Project	IEEE 802.16 Broadband Wireless Access Working Group < http://iee802.org/16 >	
Title	Harmonized Comments on the Channel Models in IEEE 802.16j-06/013	
Date Submitted	2006-09-28	
Source(s)	<p>Wen Tong, wentong@nortel.com Nortel 3500 Carling Avenue Ottawa, On, K2H 8E9 Canada</p> <p>Peter Wang, peter.wang@nokia.com Nokia 6000 connection drive Irving, Texas</p> <p>I-Kang Fu, IKFu@itri.org.tw National Chiao Tung University / Industrial Technology Research Institute 1001 Ta Hsueh Road, Hsinchu , Taiwan 300, ROC</p>	<p>David Chen , david.t.chen@motorola.com Tetsu Ikeda, Tetsu.Ikeda@motorola.com Motorola Inc 1441 W. Shure Drive, Arlington Heights, IL 60004 USA</p> <p>Jun Bae Ahn, jbahn@st.co.kr SOLiD Technologies 10th Fl., IT Venture Tower East Wing, 78 Garak-Dong, Dongpa-Gu, Seoul, 138- 803 Korea.</p> <p>Changyoon Oh, changyoon.oh@samsung.com Samsung Electronic 416 Maetan-3 dong, Yeongtong-gu Suwon-si, Gyenggi-do, Korea</p>

Harmonized Comments on the Channel Models in IEEE 802.16j-06/013

This contribution captures the harmonized comments on the channel models in IEEE 802.16j-06/013. The proposed change request on the text of IEEE 802.16j-06/013 is shown as following, and the newl

Figure 1 BS-RS link with LOS/NLOS

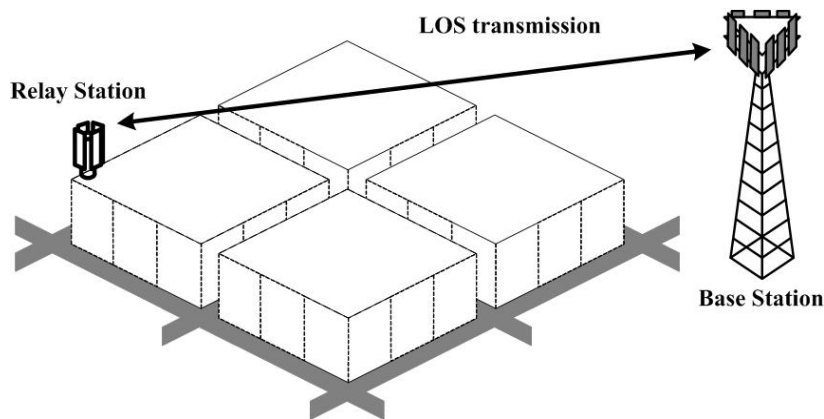
This scenario is shown in as the examples in Figure 1 and Figure 3, where both node the BS and RS antennas are mounted above the rooftops (ART) and they have a LOS between them.

Figure 2 RS-RS LOS link (ART to ART)

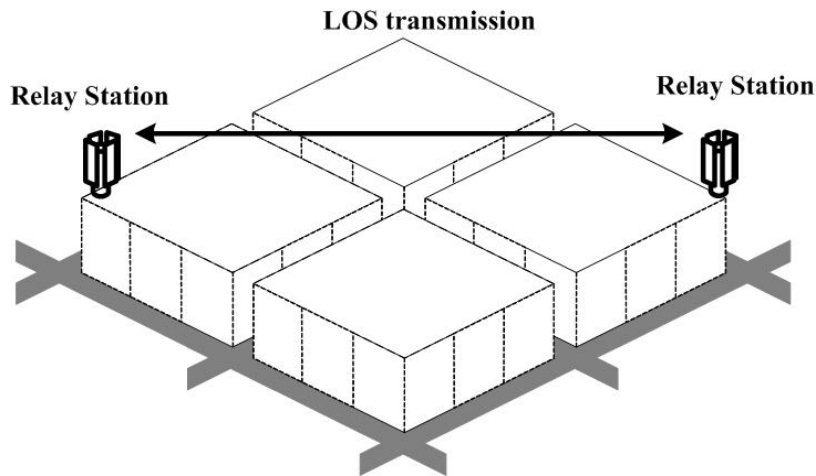
(Editor's note: Figure3 is moved to following location)

Figure 3 BS-RS NLOS (ART to BRT)

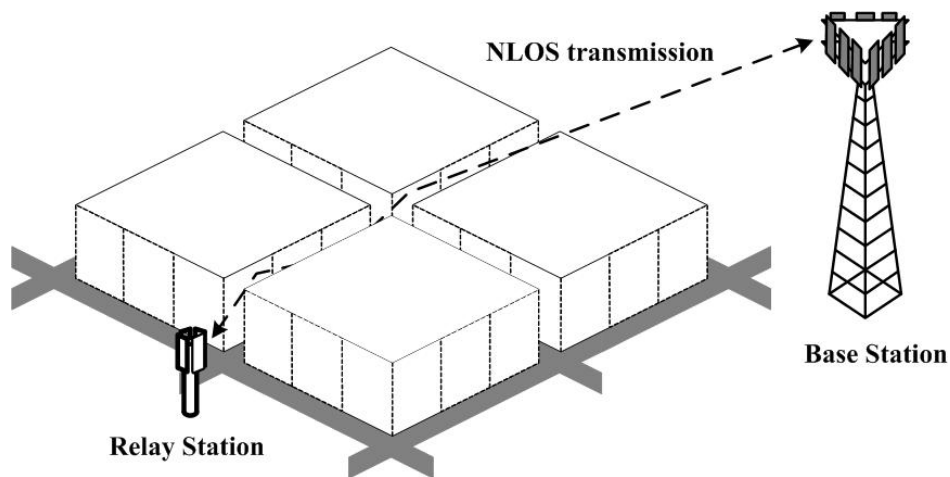
This scenario is shown illustrated in Figure 3, where in this case the BS antenna is mounted above the rooftops and the relay antenna is mounted below the rooftop (BRT).

Figure 6 RS-MS NLOS scenario

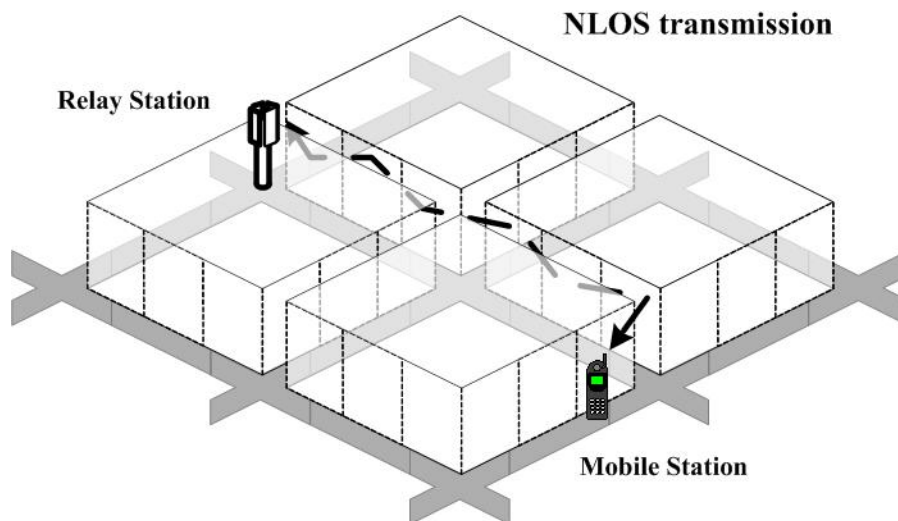
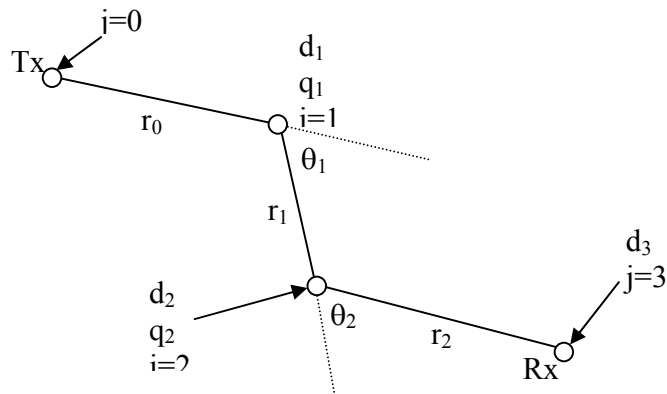
For this scenario the both node antenna RS and MS antenna heights are below rooftop and they are located on different streets.

For this case, the model takes minimum of an over-the-rooftop component and a round-the-streets component. The round-the-streets component is based on a model by Berg, although this has been modified to be compatible with the advanced LOS model, such that the visibility is included, and the effective road height to give the correct breakpoint in the first street section. The full model is shown below:

Figure 8 The alternative model for RS-MS NLOS scenario

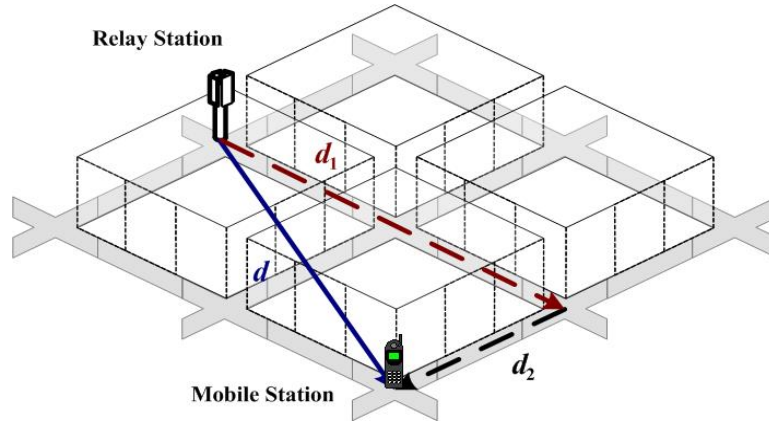
For [this](#) Type F NLOS scenario, the alternative [WINNER](#) path-loss model can be [used](#):

where d_1 is the distance along the main street in meter, ~~which is valid from 10m to 550m~~. d_2 is the distance for perpendicular street, ~~which is valid from $w/2$ m to 450m~~. w is the street width, and the carrier frequency is 5 GHz
